Access Compliance Report

Public Rights-of-Way

(Curb Ramps)

Intersection ID: 51582	Main Street: QUIVERING_OAK_LN	Cross Street: WESLEY_VILLAGE_RD	Location: SE
ADA ID: 69B44120FCC8	Ramp Type: Perp	Initial Pass/Fail: Fail	Overall Compliance: No
Severity Score: 8.75			
Codes/Mitigation Info/Possible Solution		Field Measurements/Component Compliance

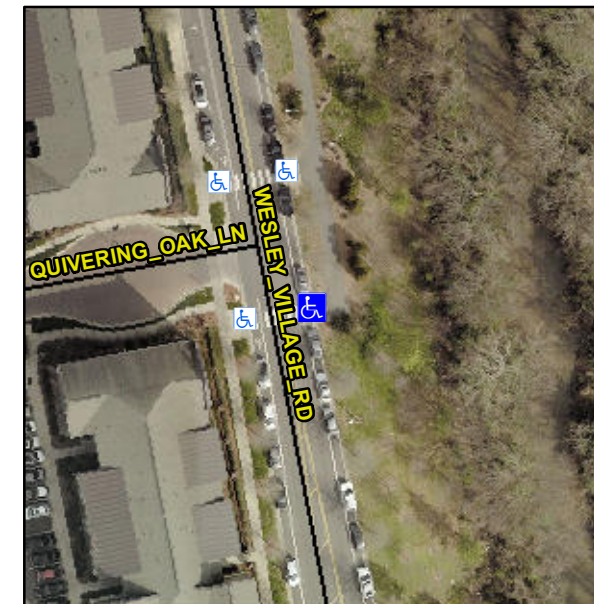
Not Found, R304.5.1

Compliance	Description	Data	Compliance	Description	Data
N/A	Ramp Length (in)	71.5	Yes	Ramp Slope (%)	6.4
No	Ramp Width (in)	47.0	Yes	Ramp XSlope (%)	1.5
N/A	Flare Type LT	N/A	N/A	Flare Type RT	N/A
N/A	Flare Slope LT (%)	N/A	N/A	Flare Slope RT (%)	N/A
N/A	Flare Traversable LT?	N/A	N/A	Flare Traversable RT?	N/A
N/A	Landing Length (in)	N/A	N/A	DWS Provided?	N/A
N/A	Landing Width (in)	N/A	N/A	DWS Contrast?	N/A
N/A	Landing Slope (%)	N/A	N/A	DWS Length (in)	N/A
N/A	Landing X Slope (%)	N/A	N/A	DWS Full Width?	N/A
N/A	Landing Curb? (Y/N)	N/A	N/A	DWS Offset (in)	N/A
N/A	Shared Landing?	N/A			
N/A	Gutter Ponding?	N/A	N/A	Gutter Slope (%)	N/A
N/A	Gutter Lip Ht (in)	N/A	N/A	Gutter X Slope (%)	N/A
N/A	Painted X Walk1?	Yes	N/A	Painted X Walk2?	N/A
	X Walk 1 Direction	To W		X Walk 2 Direction	N/A
N/A	X Walk 1 Width (in)	96.0	N/A	X Walk 2 Width (in)	N/A
	X Walk 1 Slope (%)	3.4		X Walk 2 Slope (%)	N/A
	X Walk 1 X Slope (%)	0.5		X Walk 2 X Slope (%)	N/A

Remove & Replace Entire Ramp.
